## IDAP REPORT

<b>Property:</b>	25 Long Street STRATHFIELD Lot: 1 DP: 755 DA2022.24
<b>Proposal:</b>	Demolition of existing buildings and construction of a two-storey dwelling above basement with cabana, pool and secondary dwelling to the rear of the site.
<b>Applicant:</b>	N Latif
<b>Owner:</b>	N Latif
<b>Date of lodgement:</b>	9 February 2022
<b>Notification period:</b>	14 February 2022 – 28 February 2022
<b>Submissions received:</b>	One
<b>Assessment officer:</b>	J W Brown
<b>Estimated cost of works:</b>	\$1,671,150.00
<b>Zoning:</b>	R2-Low Density Residential - SLEP 2012
<b>Heritage:</b>	No
<b>Flood affected:</b>	Yes
<b>RECOMMENDATION OF OFFICER:</b>	Approval

Figure 3: Basement plan

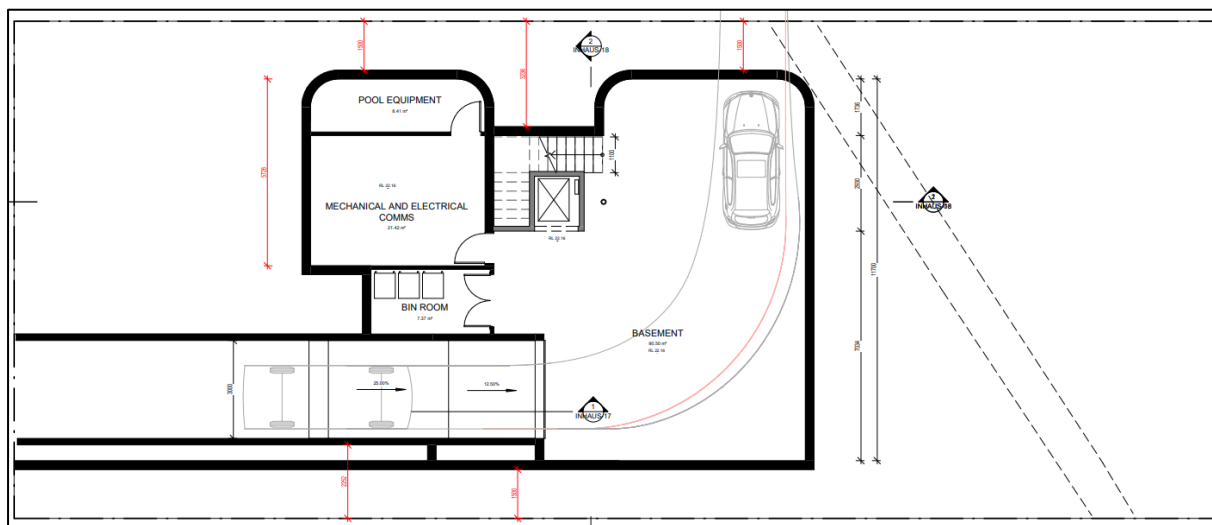
Certain sections of the basement protrude more than 1m from natural ground level. The maximum protrusion calculated from the overlay of the survey plan over the floor plan was 180mm. Therefore, the basement is considered another storey, making the development three storeys. The bin room, mechanical and electrical communication room and pool equipment room within basement therefore were calculated in FSR. As above the FSR is still compliant with the SLEP 2012 with these rooms included.

Comment: The pool equipment has been placed within the basement of the proposed dwelling and any reference to it on the eastern boundary will be removed from the plans. Thereby mitigating any issues of noise from the pool pump and equipment.

Figure 8: North (above) and East (below) elevations

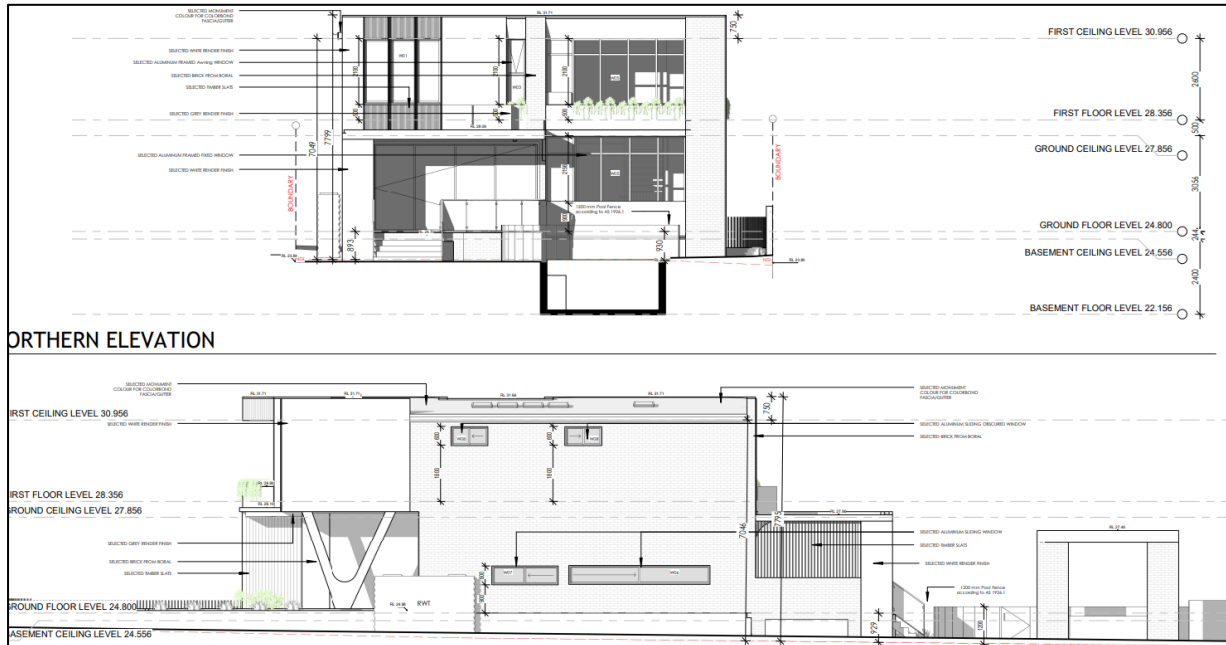
Comment: The neighbouring eastern property had concern about overshadowing caused by the proposed development. The updated plans provided by the applicant have reduced the overall height of the development by 600mm, which in turn will help with the impact of overshadowing on the eastern neighbouring property. The development is mostly compliant with the SCDCP 2005 and the impact only occurs in the afternoon due to the orientation of the lots. Therefore, the updated design is acceptable and will have minimal impacts to the neighbouring property.
